IDAP REPORT – SECTION 4.55(1A)

Property:	16 Florence Street STRATHFIELD Lot: 20 Sec: 1 DP: 581 DA 2013/43/8
Proposal:	S4.55 (1A) Redesign the space of the first-floor rumpus and WC
Applicant:	M Romic
Owner:	Ms J. Michael
Date of lodgement:	22 September 2021
Notification period:	30 September 2021 to 15 October 2021
Submissions received:	Nil
Assessment officer:	Gary Choice
Estimated cost of works:	\$400,000.00
Zoning:	R2-Low Density Residential - SLEP 2012
Heritage:	Yes
Flood affected:	No
Is a Clause 4.6 Variation Proposed:	No
RECOMMENDATION OF OFFICER:	APPROVAL

Figure 3: Proposed first floor plan

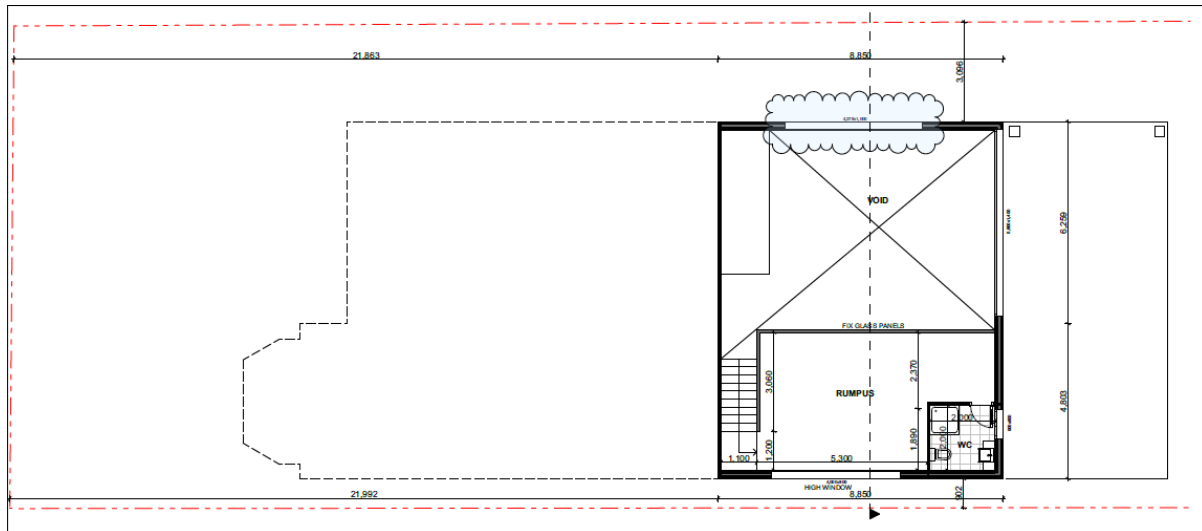
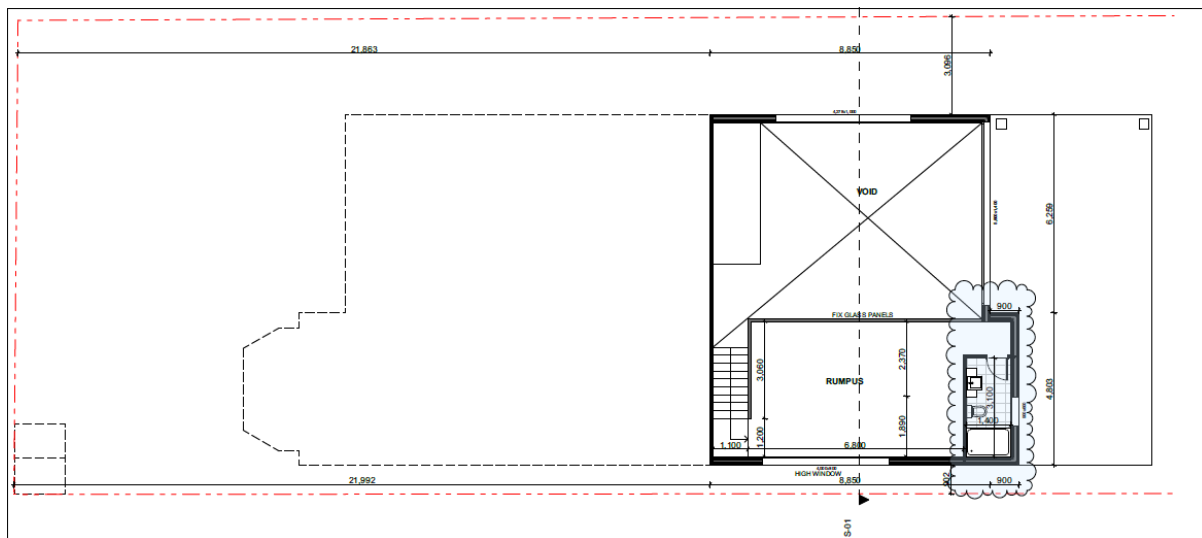
Council has received an application for the S4.55 (1A) Redesign the space of the first-floor rumpus and WC. More specifically, the proposal comprises a minor extension to the approved first floor rumpus room and bathroom including minor wall extension to create a rear cantilever and stepped rear building line.

The proposed alterations to the rear first floor will not detract from the original heritage dwelling features. The modifications are considered acceptable with regard to the provisions of this clause as the development will continue to remain hidden from view from the street so as not to impact upon the presentation of the heritage dwelling in the streetscape.

The proposed first floor modification to the rear dwelling addition does not modify the height, and will not result in excessive or inappropriate bulk or scale compared to the approved development as approved under the existing development consent. The location of the proposed modifications will retain the minimisation of visibility of the structure from the streetscape and will not detract from the architectural qualities of the heritage listed item.

Figure 7: Proposed section & west elevation

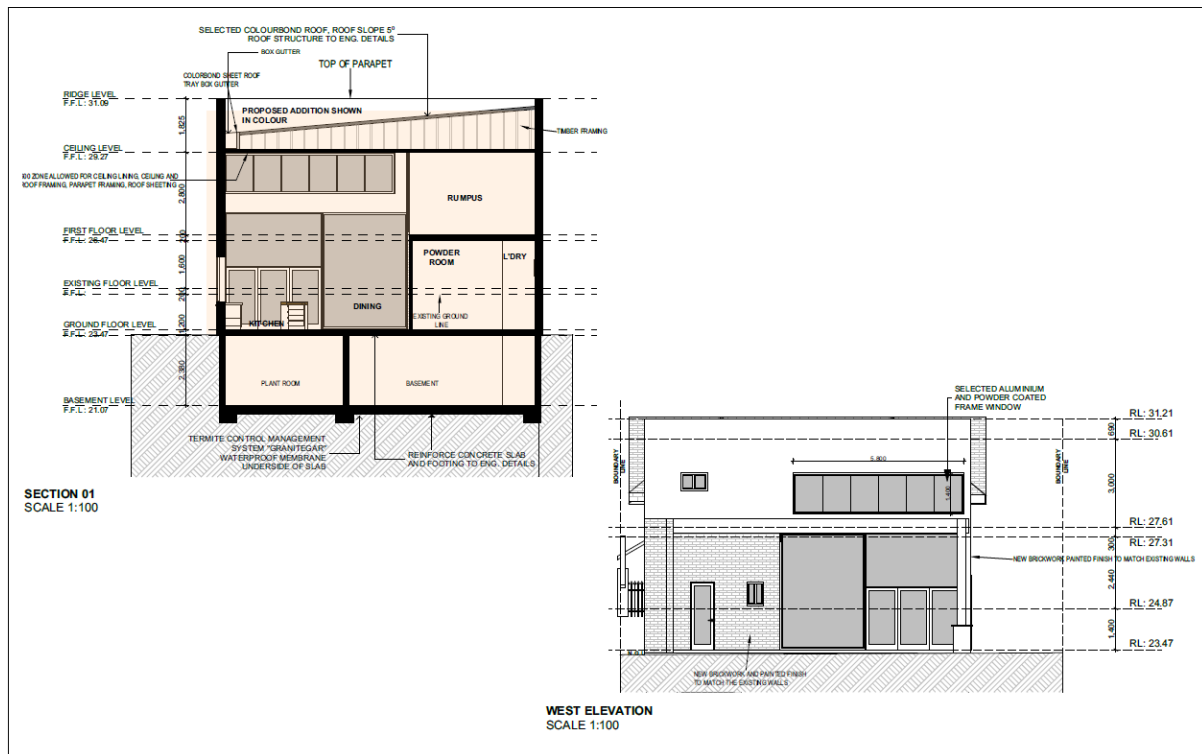
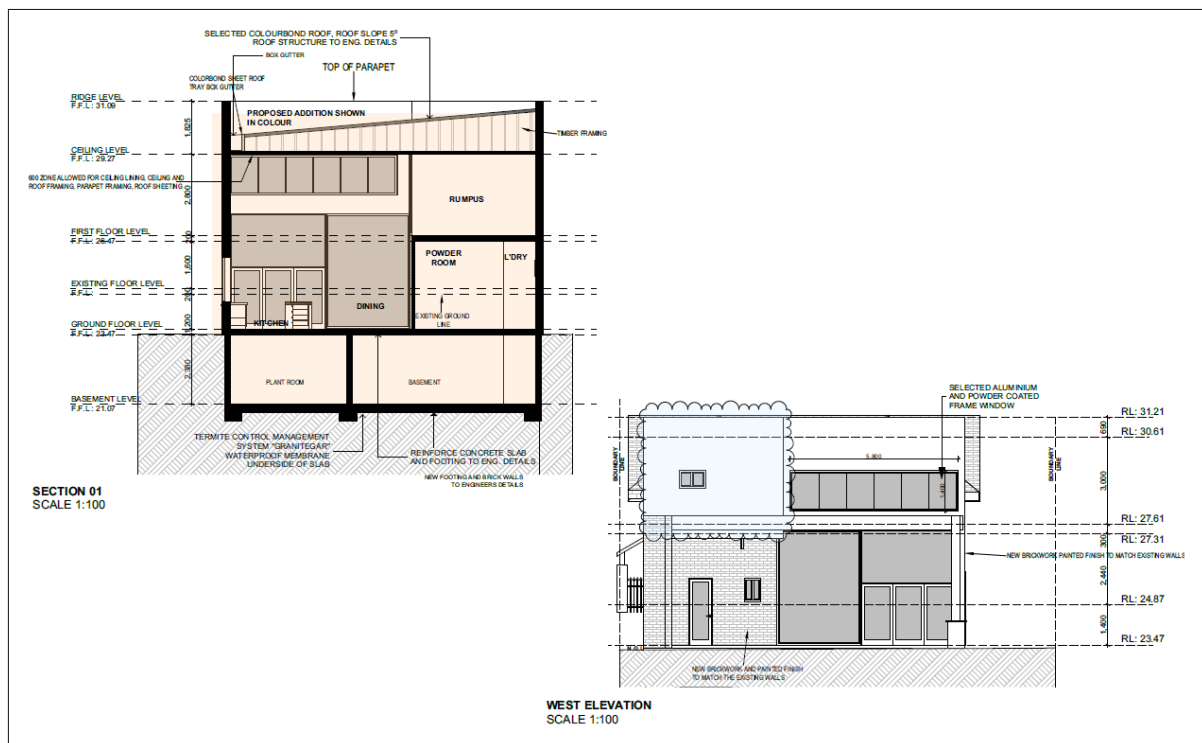
Applicable SLEP 2012 Clause	Development Standards	Development Proposal	Compliance/ Comment
4.3 Height of Buildings	Maximum building height 9.5m	The proposal does not alter the approved building heights as shown: Rear extension: 7.81m Studio/garage: 7.28m	Yes Yes
4.4C Exceptions to floor space ratio (Zone R2)	Site area: 920.3 Maximum FSR 0.525:1 or GFA: 483.2m ²	Proposed FSR 0.33:1 or GFA: 305.3m ²	Yes

The proposed modification does not alter the approved building height or dimensions of the principal dwelling basement and ground floor; or secondary dwelling. The proposed development as modified remains compliant with regard to landscaping and private open space. Additional overshadowing created by the first floor extension is considered acceptable and will not result in major impacts to the solar access of adjoining properties.
